I. C. THOMASSON ASSOCIATES, INC.

**ADDENDUM 01**

LEWISGALE HOSPITAL PULASKI  
SURGERY AHU REPLACEMENT  
ICT PROJECT #2545-01750-00

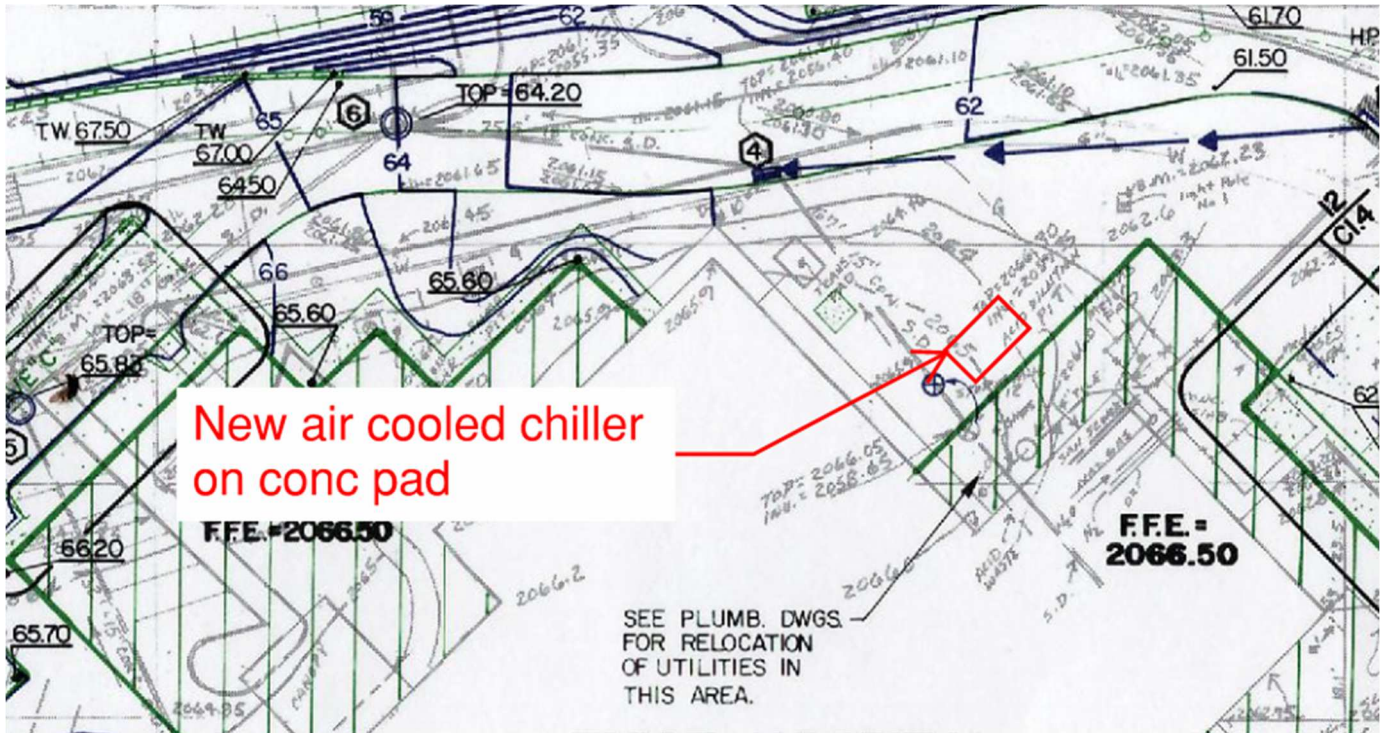
28. The existing door for OR 1 along the corridor is not shown on the plans. Please see attached PDF. Is this door to remain or is it to be demolished and the opening infilled?

Response: Door for OR #1 is existing to remain. It has been addressed in Addendum 1
